Enclosure 2
Revision to COLA Section 3.8

Enclosure 3
Revision to COLA Section 3H.6

3H.6.7 Diesel Generator Fuel Oil Storage Vaults (DGFOVS)

RAI 03.08.04-30, Supplement 1**QUESTION:****Follow-up to Question 03.08.04-23**

Figure 3H.1-1 Lateral Seismic Soil Pressure Comparison for RB East Wall (Considering RSW Tunnel & Radwaste Building)

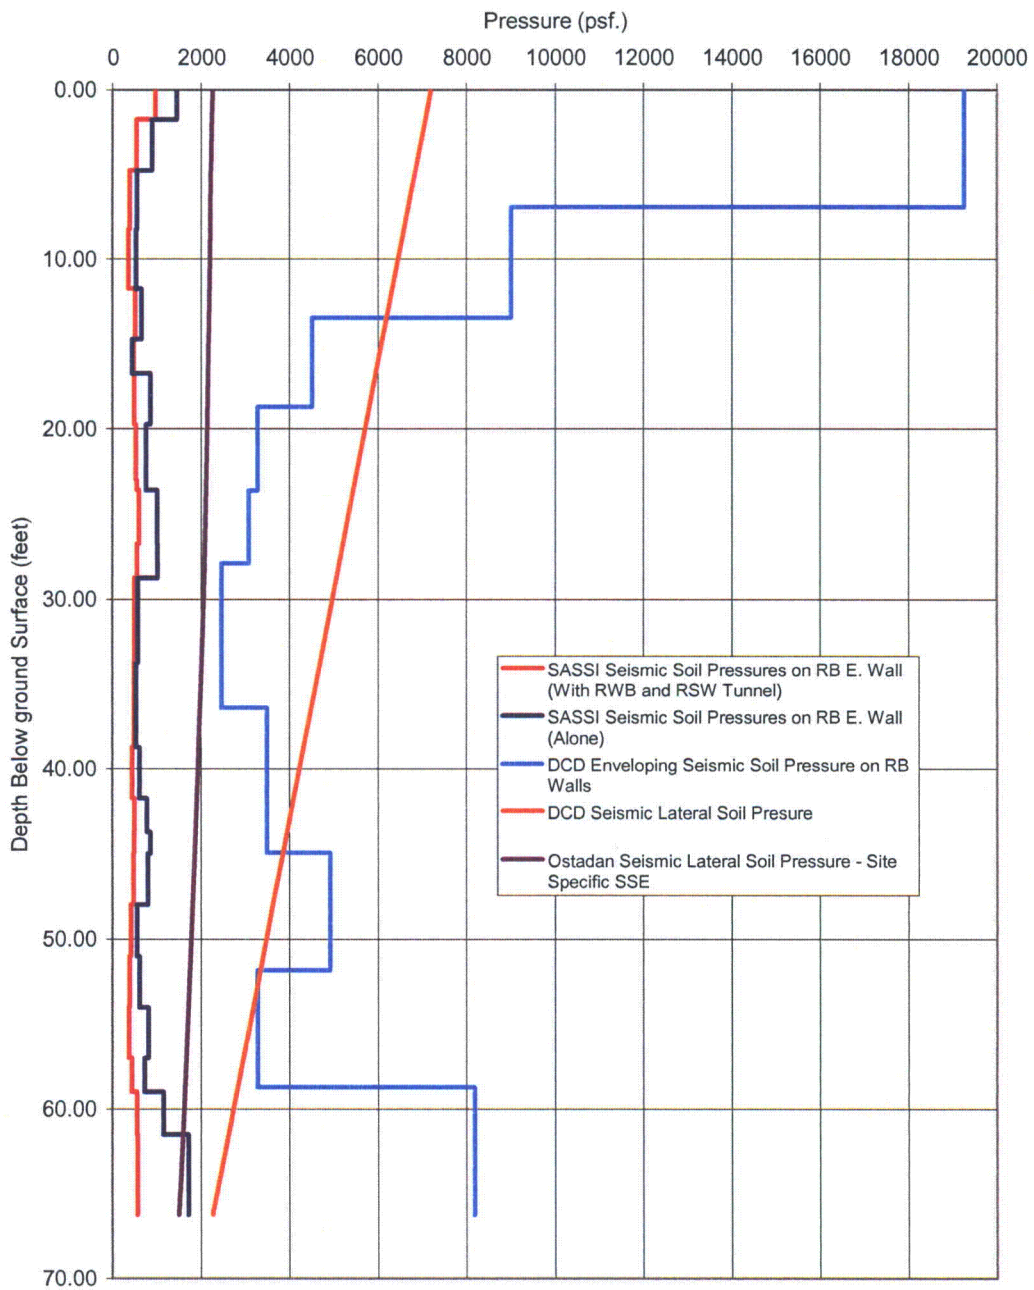
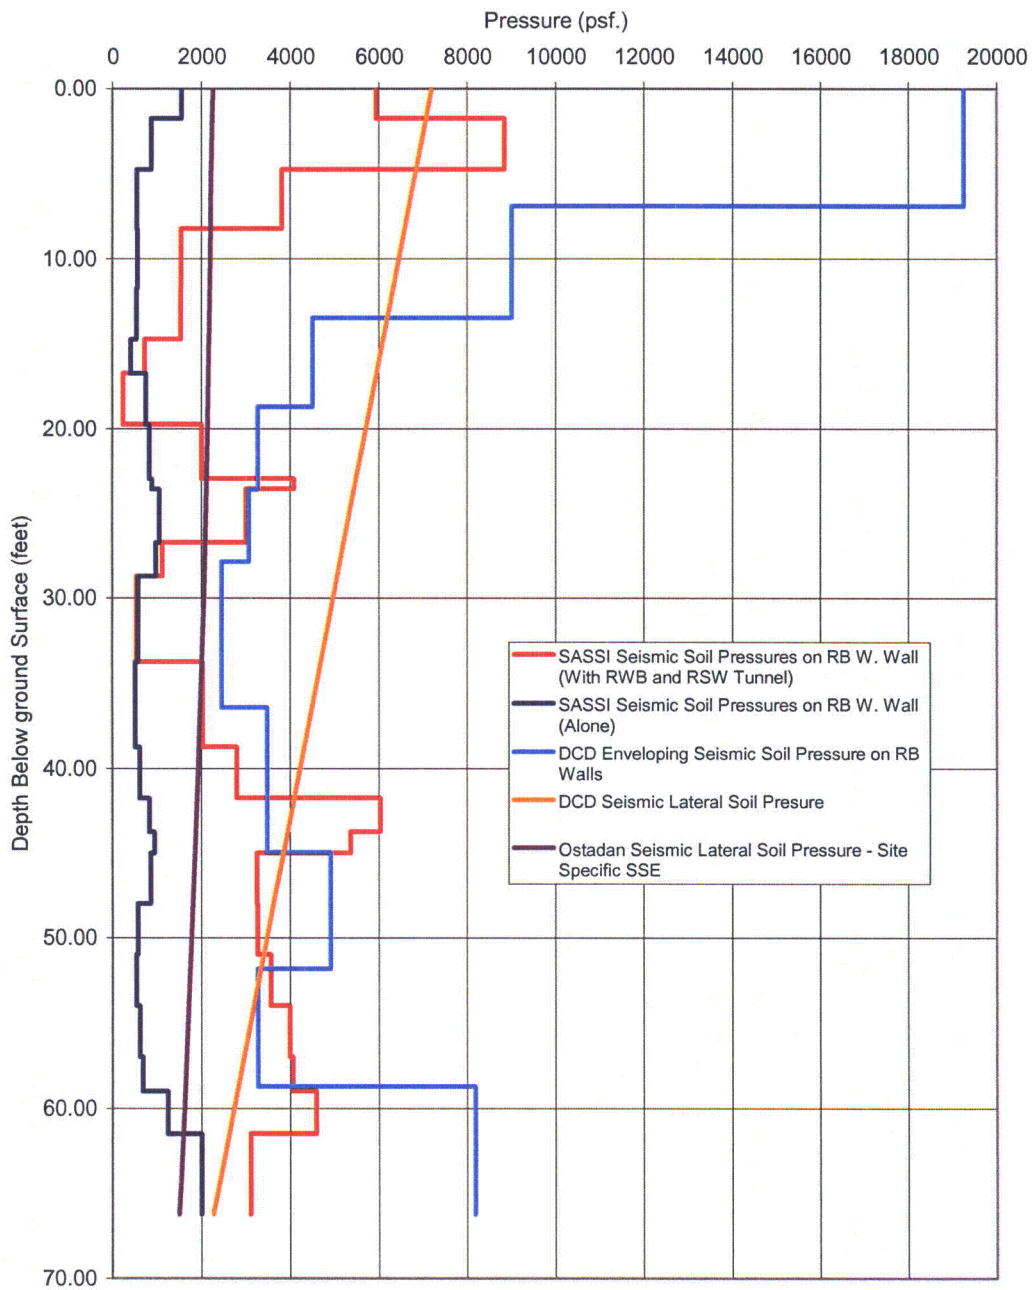
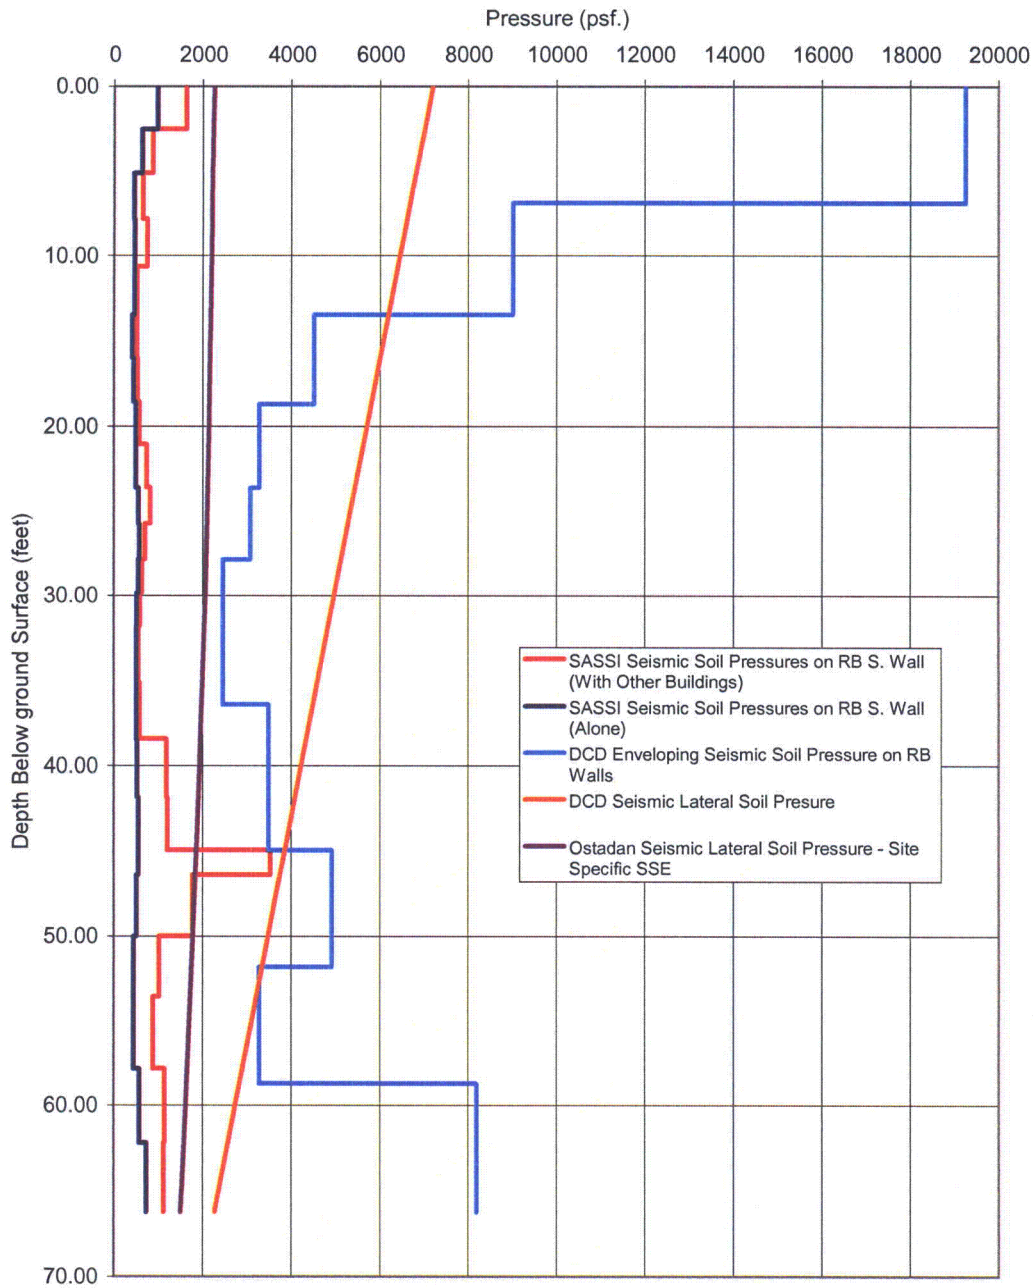
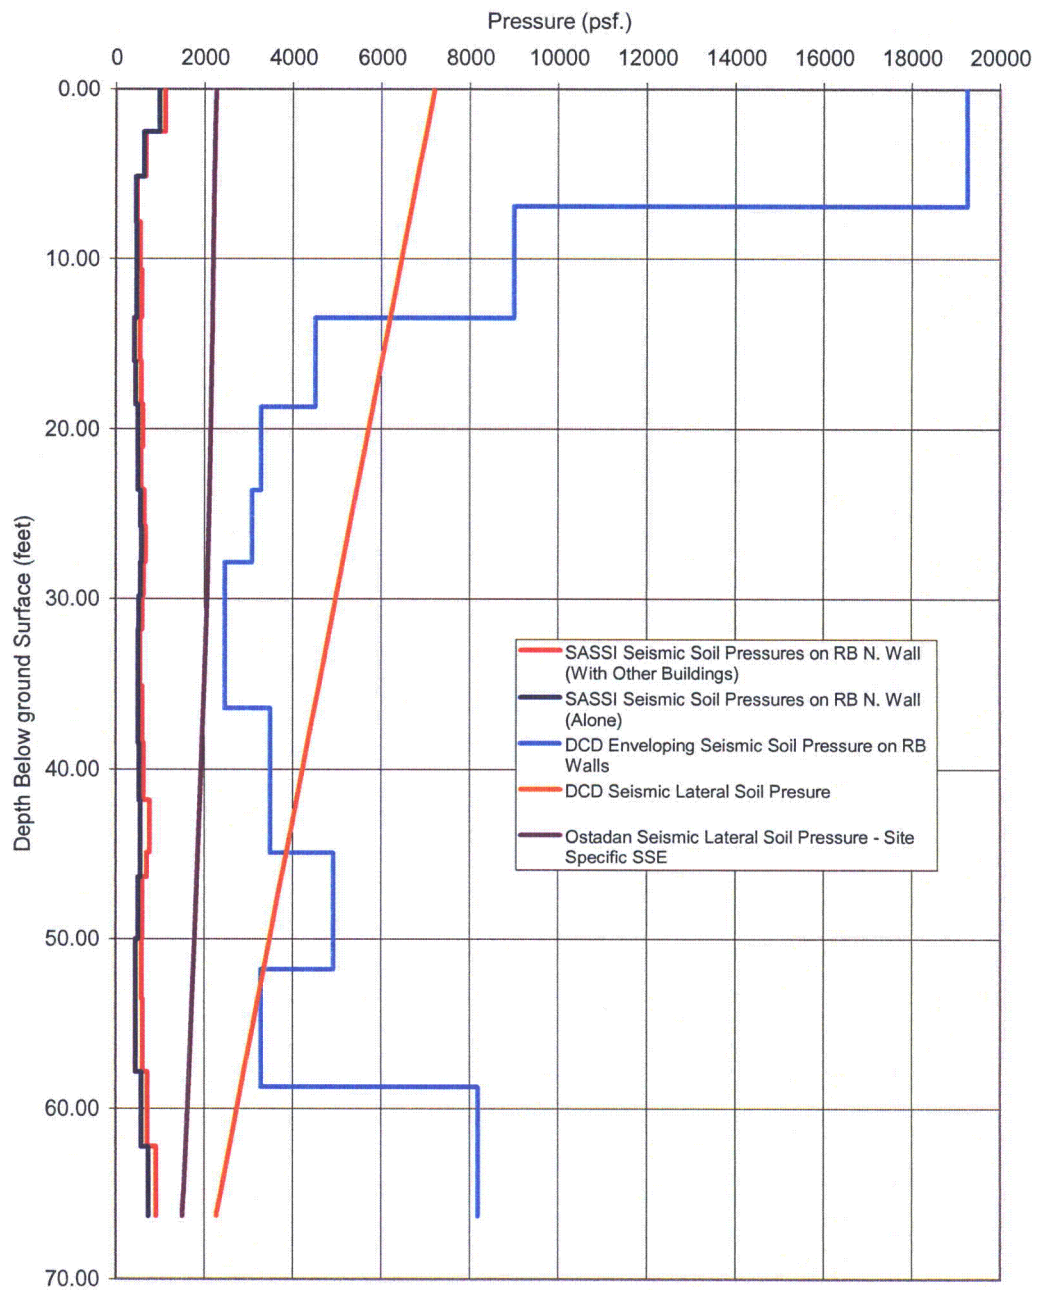
In order to assess the structure-soil-structure interaction (SSSI) effects on the lateral pressures on the walls of the Reactor Building, a two dimensional (2D) soil-structure interaction analysis was performed to determine the SSSI soil pressures. Figures 3H.1-1 through 3H.1-6, included in Enclosure 2 of this response, show a comparison of the lateral seismic soil pressures provided in
